State of New Mexico
ENVIRONMENT DEPARTMENT

RE: Response to informal Chino comment letter on the Human Health Risk Assessment
Smelter and Tailing Soils Investigation Unit (S/TSIU)
Chino Administrative Order on Consent (AOC)

The Ground Water Quality Bureau of the New Mexico Environment Department (NMED) received the informal Chino Mines Company comment letter on November 16, 2007. NMED and Gradient Corporation reviewed the comment letter and provides the following responses to the Chino comments.

Fig 5. Solid-phase emptying patterns for filling meal (mean weight ingested = 1692 g), 900-g, and 300-g meals. $N = 10$ for filling meals. $N =$ for 900- and 300-g meals. *Represents mid-meal time.

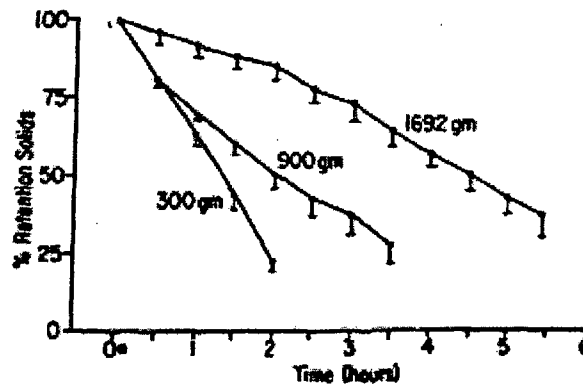
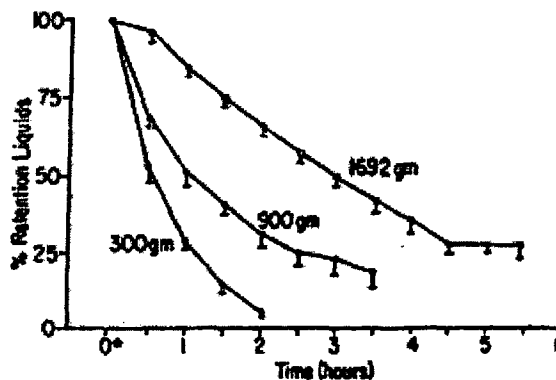
Gradient has reviewed several of the studies cited by LINEA and the data presented in these studies support Gradient's selection of three hours as the time required for the stomach to empty after a meal (which is based on Maltby, 2000, who reported a range of 3-5 hours as the time required for the stomach to empty after a meal). The figures below (Figures 5 and 6) are from the study by Moore *et al.* (1981) that was cited by LINEA. These figures show gastric emptying for solids (Figure 5) and liquids (Figure 6) following ingestion of meal sizes of 300, 900 and 1,692 grams. These graphs indicate that gastric emptying is a function of meal size, with faster emptying rates for smaller meals; and that gastric emptying differs for solids vs. liquids, with liquids emptying at a faster rate, in an exponential manner, and solids emptying at a slower rate in a linear manner. Because Gradient assumed a meal size of 317 grams, it is most appropriate to consider gastric emptying rates for the 300-gram meal. If the line in Figure 5 for the 300-gram meal were extended, it would cross the x-axis (at which point the stomach would be empty) at approximately 2.5 hours. Figure 6 indicates that approximately 100% of liquids would be emptied from the stomach within two hours. Hence, the data from the study by Moore *et al.* suggests that if anything, the RAC analysis should have been based on an emptying time of less than three hours.

which is approximately linear, the time required for the stomach to completely empty would be approximately 156 minutes, or 2.6 hours (which agrees with emptying time for the 300 gram meal from the study by Moore *et al.*, 1981, discussed above). Similarly, the half-times for solids reported by Van Den Driessche *et al.* (2000) of 60-81 minutes for boys, and 66-88 minutes for girls, would correspond with emptying times of 2 – 2.7 hours for boys, and 2.2 – 2.9 hours for girls.

Note that it is not appropriate to compare the half-life for Gradient's analysis, in which the process of gastric emptying was assumed to follow an exponential decay function, with half-lives for solids from the studies discussed above, for which gastric emptying was observed to be linear. An exponential decay function will have a shorter half-life than a linear decay function, even if the total time for the stomach to empty is the same.
